QUALITY ASSURANCE -- NON-CONFORMANCE REPORT

Report No: NCR-000637

Reference Description: ZPMC used different type filler wires performing the weld repair at the joint connecting 345 grade to 485 grade material located at West Tower Lift 4

Job Name: SAS Superstructure
Document No: 05.03.06-000597

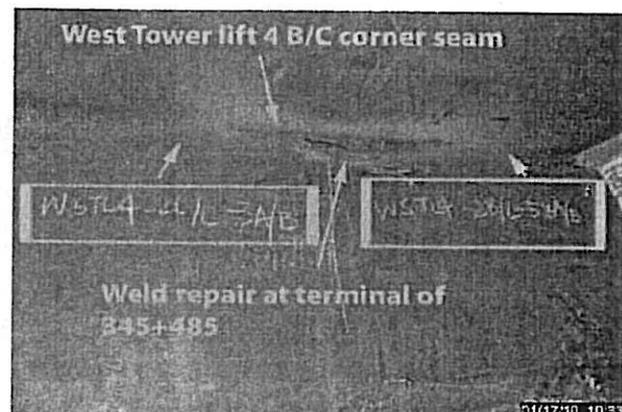
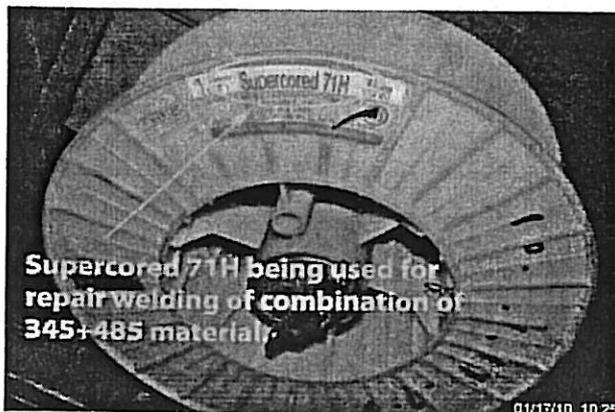
Reference Description: ZPMC used different type filler wires performing the weld repair at the joint connecting 345 grade to 485 grade material located at West Tower Lift 4

- ZPMC welding personnel performing weld repair of B/C corner seam of West tower lift 4 using Flux Cored Arc Welding (FCAW) process.
- The weld numbers are identified as WSTL4-2L/L-3A/B for 485 grade material and WSTL4-2B/L-58A/B for 345 grade material.
- ZPMC personnel performing the weld repair at the joint connecting 345 grade to 485 grade material using WPS-345-FCAW-1G(1F)-REPAIR with Supercored 71H filler wire.
- The required filler wire for welding of these joints is K-71TSR with WPS-345+485-FCAW-1G-REPAIR.
- The weld joint is a Complete Joint Penetration (CJP) weld.
- The material is designated as non Seismic Performance Critical Member (non SPCM).
- The member is located at Tower bay no. 11.

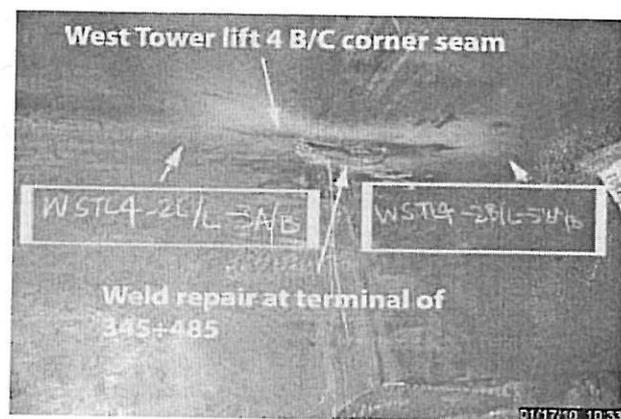
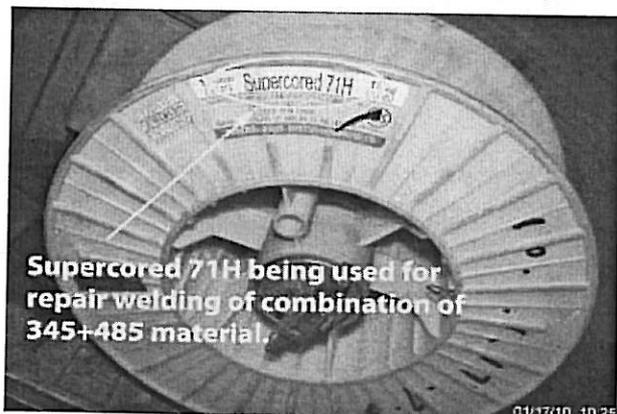
Reference Description: ZPMC used different type filler wires performing the weld repair at the joint connecting 345 grade to 485 grade material located at West Tower Lift 4

- ZPMC welding personnel performing weld repair of B/C corner seam of West tower lift 4 using Flux Cored Arc Welding (FCAW) process.
- The weld numbers are identified as WSTL4-2L/L-3A/B for 485 grade material and WSTL4-2B/L-58A/B for 345 grade material.
- ZPMC personnel performing the weld repair at the joint connecting 345 grade to 485 grade material using WPS-345-FCAW-1G(1F)-REPAIR with Supercored 71H filler wire.
- The required filler wire for welding of these joints is K-71TSR with WPS-345+485-FCAW-1G-REPAIR.
- The weld joint is a Complete Joint Penetration (CJP) weld.
- The material is designated as non Seismic Performance Critical Member (non SPCM).
- The member is located at Tower bay no. 11.
